AMENDED BY STAFF 7/23/87
CITY PLANNING COMMISSION

- APPLICATION:**
- A. Negative Declaration
 - B. Special Permit to construct a 69 unit apartment complex in the R-2B-PUD zone.
 - C. Variance to the LPPT PUD Guidelines to reduce 15 foot setback requirements for carports to 7 feet.
 - D. Variance to LPPT PUD Guidelines to reduce 25 foot setback for one-story structures to 15 ft.

PROPOSAL: The applicant is requesting the necessary entitlements to construct a 69 unit apartment complex in the R-2B-PUD zone and the LPPT-PUD (site 10).

APPLC. NO. P87-287 **MEETING DATE:** July 23, 1987 **ITEM NO** 14

EXHIBIT A
Site Plan

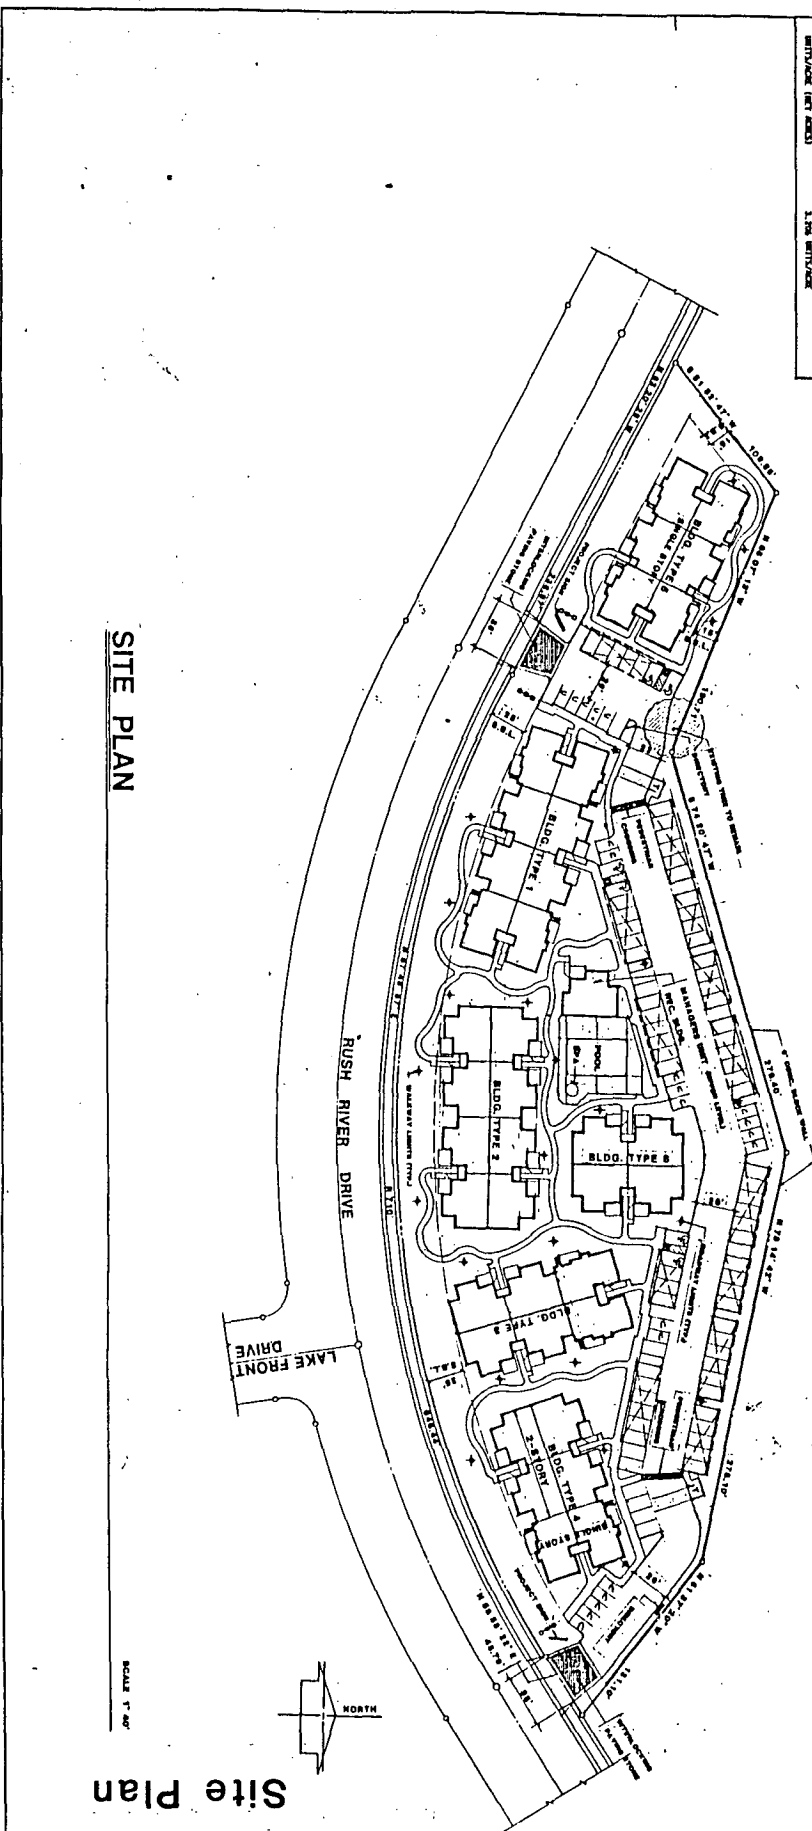
The subject site is irregular in shape and the applicant has designed the site plan so that the covered parking stalls are a minimum of seven feet from the north property line. The LPPT PUD Guidelines indicate that the covered stalls should be a minimum of 15 ft. from adjacent single family residences to act as a noise and visual buffer. The subject site, however, is at a lower grade than the adjacent single family lots and the carport structures will be lower than the lots to the north. The property line on the north runs along the middle of the slope and the applicant has an easement with the present property owner of the single family lots, Citation Homes, to landscape this slope. Planning staff recommends that, in order to minimize the impact of the parking area on future single family residences, the applicant should, if possible, construct the required six foot high masonry wall between the parking lot and the single family homes at the top of the slope and landscape the slope. If this is not possible, staff recommends that the required wall be constructed on the subject site so that it measures six feet from the highest grade of the adjacent single family lots. This height will provide the future residences to the north with an adequate noise and visual buffer. Staff also recommends that the design of the carports be subject to Planning staff review and approval with a decorative feature being incorporated on the top of the carports.

The western portion of the subject site is 109 feet in depth and in order to maintain the required 25 foot landscaped setback along Rush River Drive, a portion of the six unit, one story building proposed for this area is 15 feet away from the north and west property lines. Planning staff recommends that the six foot high masonry wall required for a portion of the north property line be extended along the entire north and west property lines to insure the occupants of these adjacent single family residences their privacy. The wall would not be required in the 25 foot landscaped setback area. The landscape plan indicates a variety of trees and shrubs between the units and the property line which will also act as a noise and visual buffer for the single family residences.

The submitted site plan indicates several light fixtures along the north property line. These light fixtures need to be screened and oriented away from the adjacent single family lots so they do not produce an annoying glare to adjacent residential uses.

Several of the apartment units have their front doors facing Rush River Drive. Planning staff is concerned that due to the configuration of the buildings and the location of the parking lot at the rear of the site, people will be tempted to park on Rush River Drive and walk across the landscape setback to the apartment units. Staff finds that excess on-street parking would detract from the appearance of the apartment project and produce unnecessary wear-and-tear on the landscaped area. Staff, therefore, recommends that a four foot high decorative wrought iron fence be placed in the 25 foot landscaped setback area in order to discourage unnecessary on-street parking and maintain the appearance of the site.

One hundred and nine (109) parking spaces are indicated on the site plan. Sixty-nine (69) of these spaces are covered. These spaces meet the Zoning Ordinance and PUD parking requirements. Guest parking should be clearly marked and scattered throughout the site. Bicycle parking will need to be indicated on the revised site plan.

1. Revised landscape, shading and irrigation plans shall be submitted for Planning Director review and approval prior to issuance of building permits. The revised plans shall indicate either a minimum four foot high decorative wrought iron fence, three foot high decorative wall, or some other decorative barrier which prevents people from walking across the landscape setback, in the 25 foot landscaped setback area. The design of this barrier is subject to Planning Director review and approval. The revised plans shall also indicate heavy landscaping between the single story building and the north and west property lines, the existing trees on the subject site and their species, and shall follow the requirements of the LPPT PUD Guidelines.

2. The applicant shall provide a decorative masonry wall between the parking lot and driveway areas adjacent to the north and east property lines. If possible, the applicant shall construct the northern portion of the wall off-site on the adjacent single family lots at the top of the slope and landscape the common slope area of the apartment site and adjacent single family lots. If this is not possible, the applicant shall construct the wall on the subject site so that it measures six feet in height from the highest grade of the adjacent single family lots. Wall design and materials shall be subject to Planning Director review and approval.

3. A lighting plan for the project shall be provided and lighting shall be screened and oriented so that it does not produce an annoying glare to adjacent residential uses.

4. The applicant shall provide a six foot high decorative masonry wall along the north and west property lines adjacent to the two existing single family residences. A portion or all of this wall may be waived if the adjacent property owners agree. The wall shall not extend into the 25 foot landscape setback area.

5. Elevations for the carports shall be submitted for Planning Director review and approval prior to issuance of building permits. The carports shall utilize a decorative wood or metal trim facia and a decorative element shall be incorporated on the top of the carport.
